Planning Department
David Campbell, Director

RE: **Lot 35 Block 8, Volcano Cliffs, Unit 22, SAD 228**
6423 Picardia NW
Grading and Drainage Plan
Engineers Stamp Date 10/1/18 (D10D003E35)

DRAINAGE AND TRANSPORTATION INFORMATION SHEET (REV 6/2018)

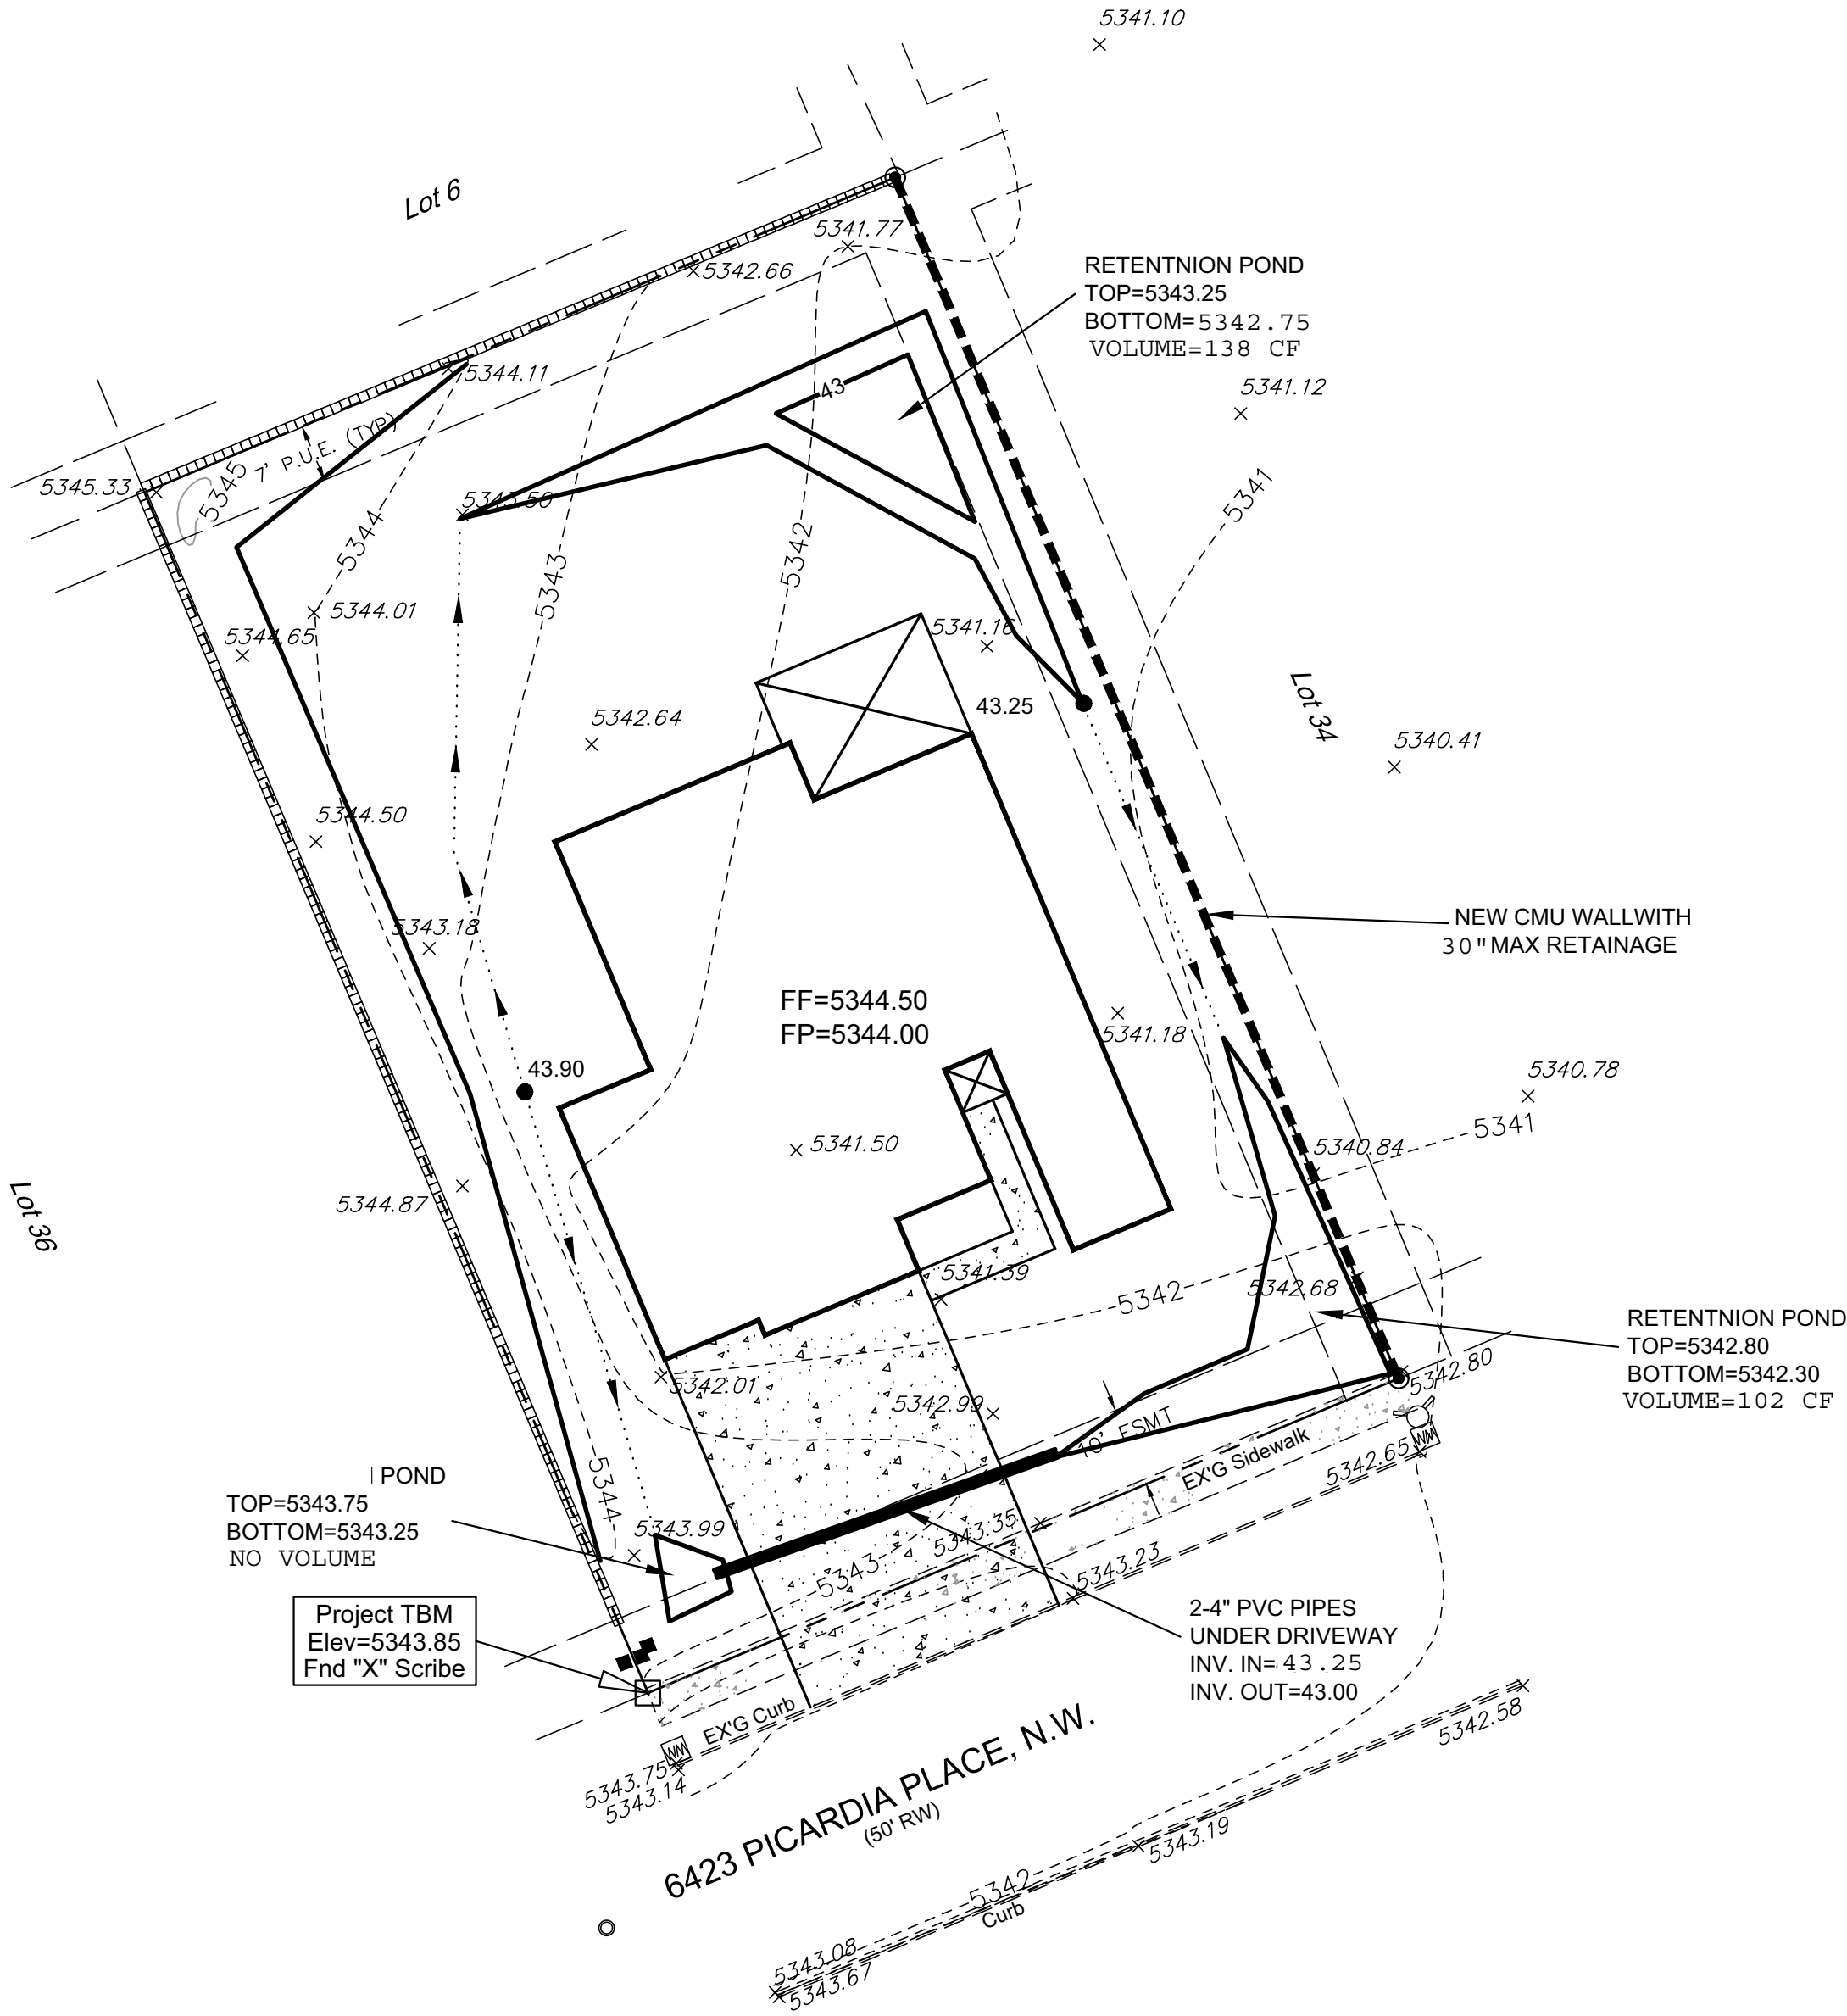
Based upon the information provided in your submittal received 10/1/18, this plan is approved for Grading Permit.

Prior to Building permit approval a Pad Certification will be required, provided by the Engineer or a registered Land Surveyor.

Reiterate to the Owner/Contractor that a separate permit for a garden/retaining wall must be obtained with the approved G&D plan and Pad Certification.

Prior to Certificate of Occupancy release, Engineer Certification per the DPM checklist is required.
